RESOLUTION R-171-18

**A RESOLUTION APPROVING COMPREHENSIVE DEVELOPMENT PLAN AMENDMENT 3
FOR STONER PRAIRIE, CDP(A)-2234-18**

Comprehensive Development Plan Amendment Three Stoner Prairie Neighborhood

Application: Comprehensive Development Plan Amendment (CDP(A)), Certified Survey Map (CS), Rezoning (RZ)
Property Location: Outlot 4 CSM 14388
Review Date: August 31, 2018
Planning Staff Review #1

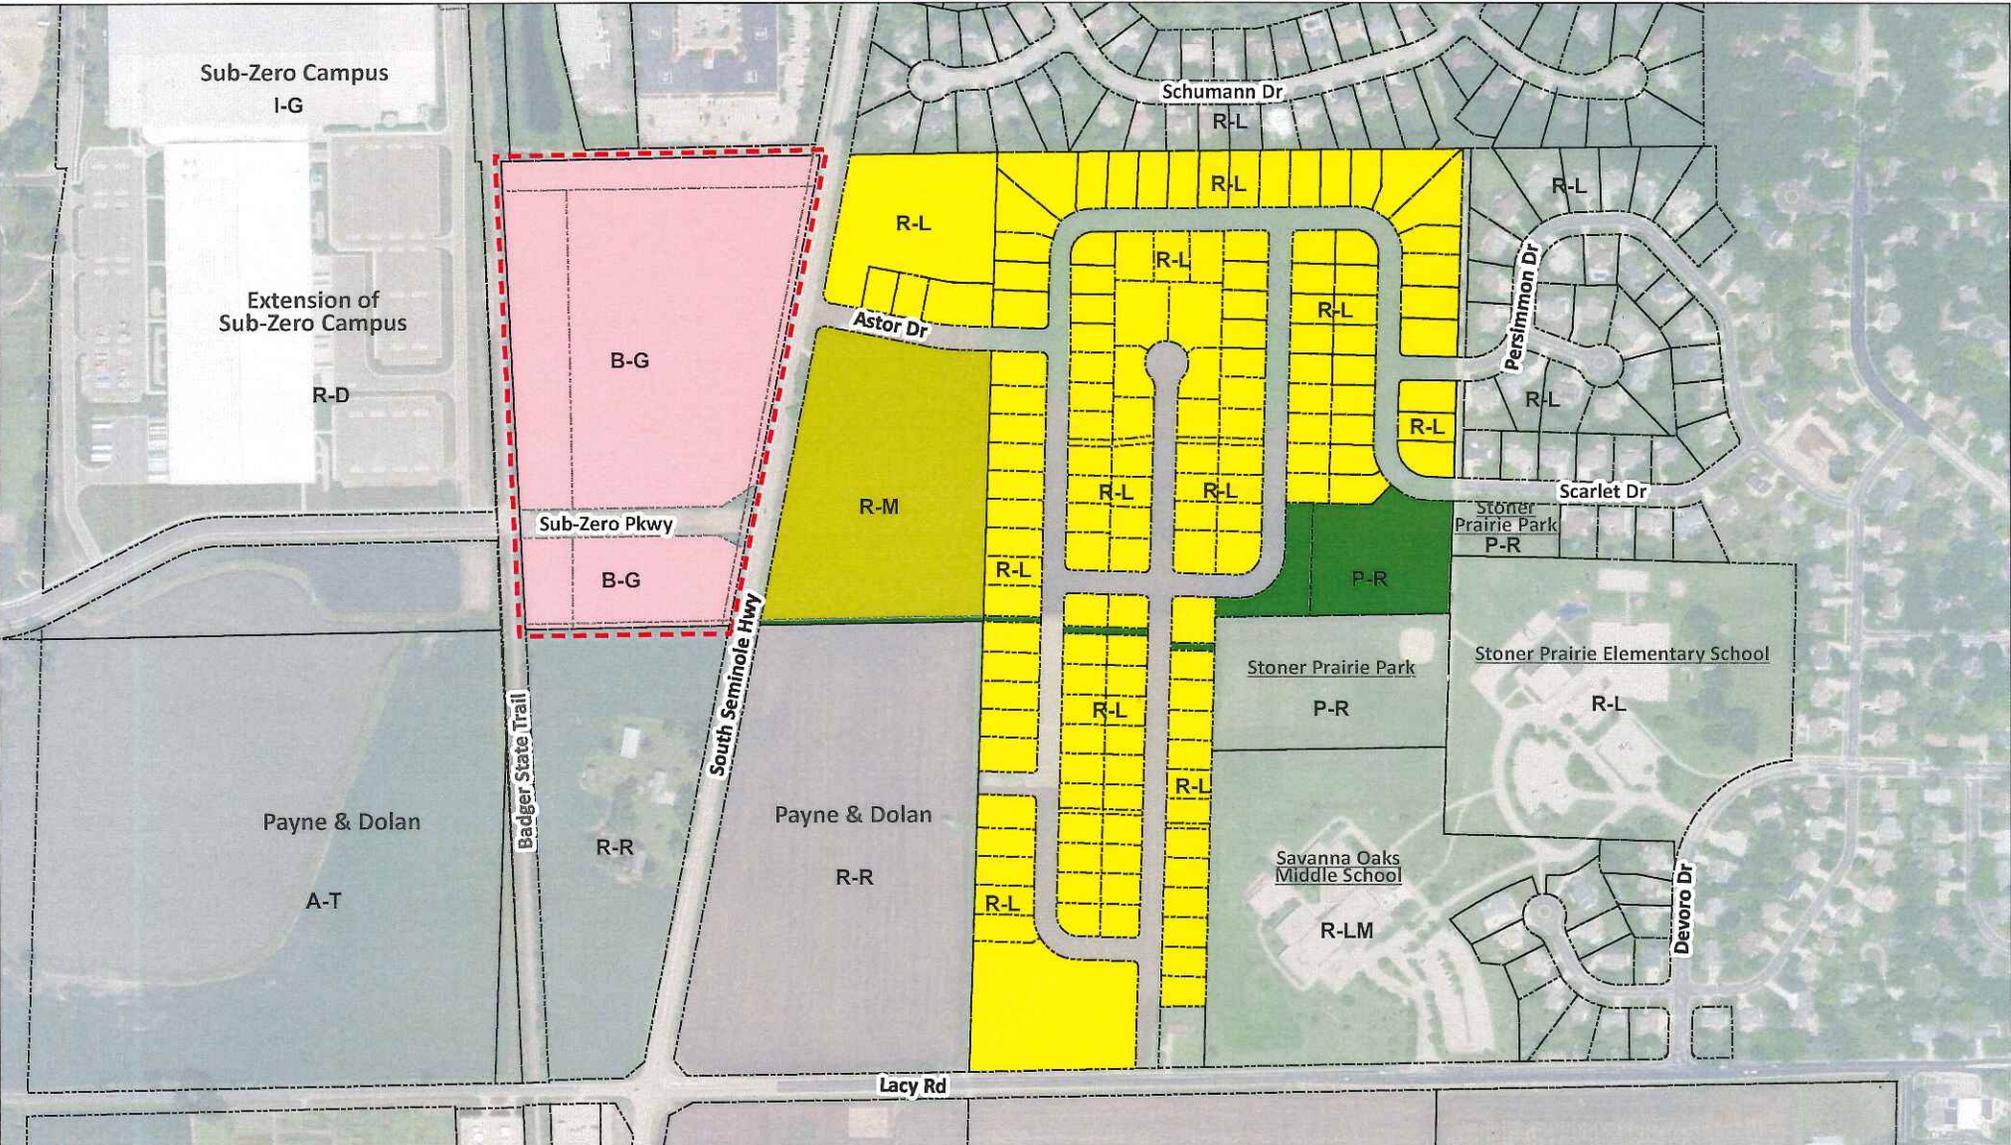
- The Environmental Corridor designation on the Dunn property was identified due to the potential for wetlands, and due to the presence of a natural Closed Depression system that is used for groundwater recharge and stormwater **detention and infiltration**. Absence of wetlands does not eliminate the environmental corridor status.
- The Environmental Corridor was identified and designated as part of the planning process for the City of Fitchburg's North Stoner Neighborhood Plan and the CARPC Resolution 2014-14 for the USA Amendment.

- Moving ~~and/or eliminating~~ the Environmental Corridor designation is possible, but only if the **hydraulic hydrologic (detention and infiltration)** functions of the Closed Depression are preserved elsewhere, and shown through Stormwater Analysis/Calculations.
- ~~Elimination~~ **Moving** of the Environmental Corridor would be a Proposed Stormwater Management Facility change, and would be considered a Minor Change.
- The Minor Change process would require the submittal of a Site Plan, and appropriate Stormwater Analysis and Calculations, showing that the property would maintain the **hydraulic hydrologic (detention and infiltration)** functions of the Closed Depressions.
- The timeline for a formal request to CARPC is approximately 2 weeks; a decision on this issue could be reasonably expected to follow the same timeline.

Just a couple of corrections/clarifications as noted below in red.

The Environmental Corridor cannot be eliminated without a Major Change, but it can potentially be moved to the location of the constructed stormwater management practices that are proposed to replace the hydrologic (detention and infiltration) functions of the existing Closed Depression.
